Report to Sydney Central City Planning Panel

SCCPP reference	PPSSCC-491
DA No.	DA/573/2023
Date of receipt	25 September 2023
Proposal	Demolition of existing structures on site and construction and use of two warehouse or distribution centres to operate 24 hours a day 7 days a week. The development includes associated earthworks, construction of an ancillary office space, at grade car parking for 85 vehicles, private access road, loading bays, landscaping, café and two drainage basins. This is integrated development under Section 91(2) of the Water Management Act 2000. This development will be determined by the Sydney Central City Planning Panel.
Street address	1 Grand Avenue, Camellia
Property Description	Lot 1 DP 579735, Lot 2 DP 579735 and Lot 2 DP 1248549
Applicant	The Trustee for Grand Avenue Trust
Owner	Billbergia Group Pty Ltd
Submissions	Nil
Recommendation	Deferral until 5 December 2024
Regional Development Criteria	Pursuant to Part 3 of Schedule 2 of the Environmental Planning and Assessment Act 1979, the development has a capital investment value of more than \$30 million

Figure 1 - Aerial map, subject site highlighted in blue. Existing Council stormwater pipe shown as red line (Source: Neatmap, 2024)

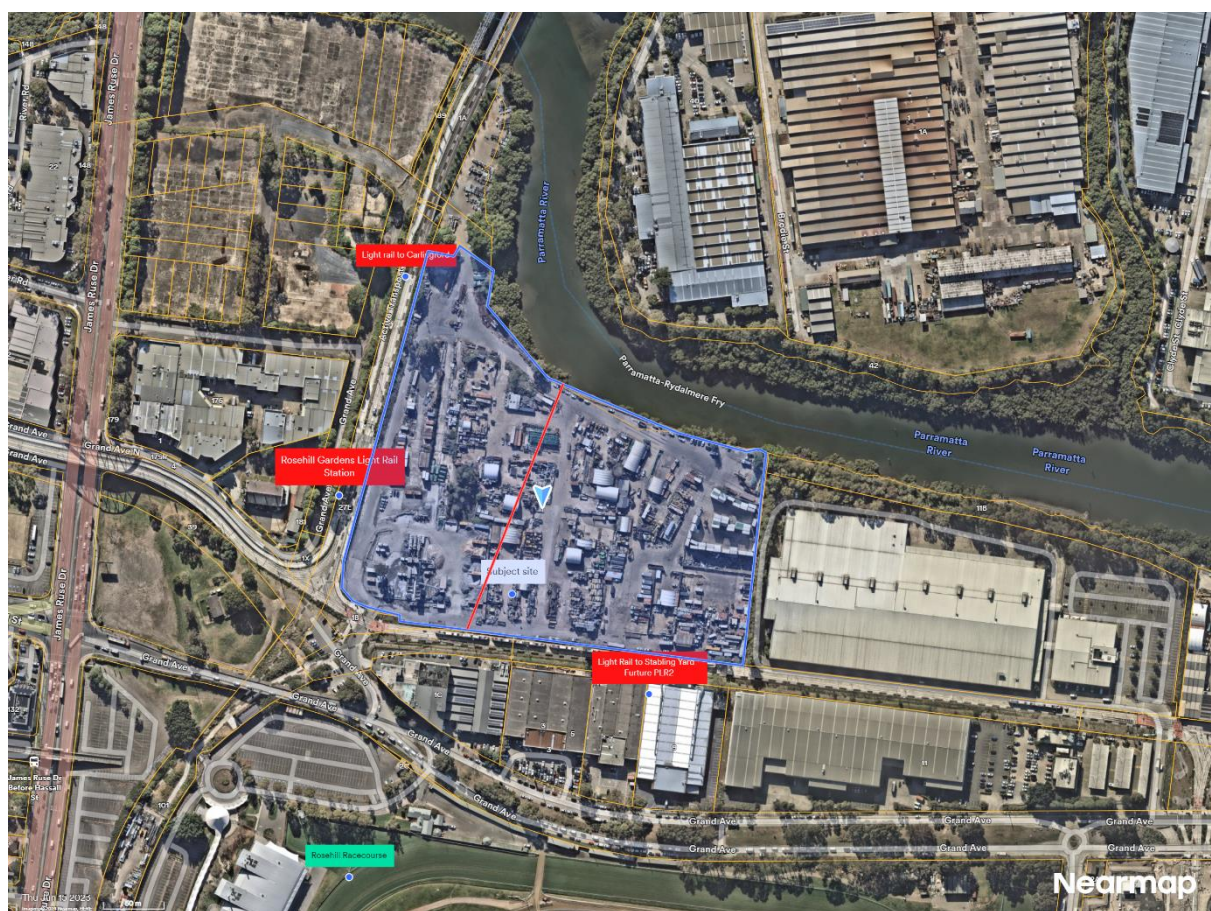
The proposal also includes building over a Council stormwater pipeline, which would hinder Council's ability to service the pipe. An overland flow path will also be required to provide for any potential blockages of said pipe.

There is a Council stormwater pipe bisecting the site from south to north. No easement exists for this pipe. An indicative location for the pipe is shown in figure 1 below.

Figure 17 - site roof plan with height plane

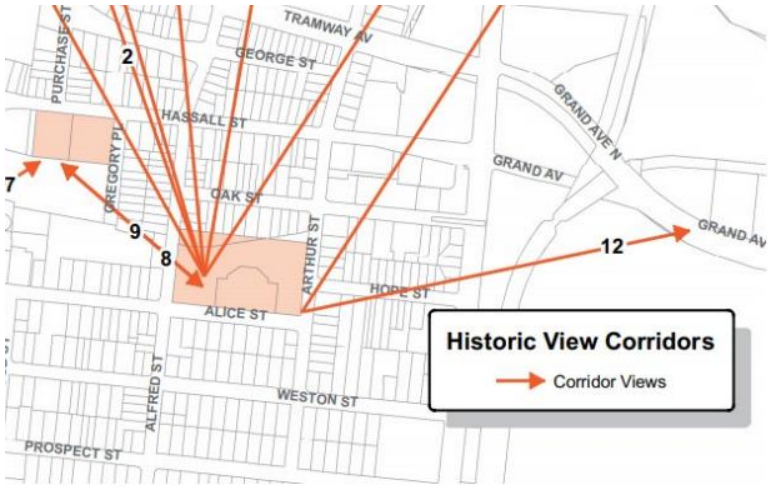
Comment: It is demonstrated that some sites within this area have exceeded this height control. With respect to scale, the bulk of the building has been designed sympathetically to the surrounding area accounting for the environmental constraints of the site by providing suitable setbacks to the river and light rail corridors.

It is considered that the proposed bulk and scale of the building is generally mitigated by appropriate facade modulation and materials. The bulk and scale of the proposal is commensurate and compatible with that of the nearby development along Grand Ave.

Overall, the building will not be out of character in the streetscape along the river and light rail corridors, further, it is considered that the development respects the existing character of the area and any potential adverse effects on the surrounding environment in respect to building height will be negligible.

Council conclusion: It is considered that the applicant's written request has adequately addressed the matters required to be demonstrated and that the request to vary the height development standard within Parramatta LEP 2023 can be supported as the proposal achieves the objectives of the height development standard and zone, there are sufficient site-specific reasons for the breach, and the proposal is in the public interest. In reaching this conclusion, regard has been given to the relevant Judgements of the LEC.
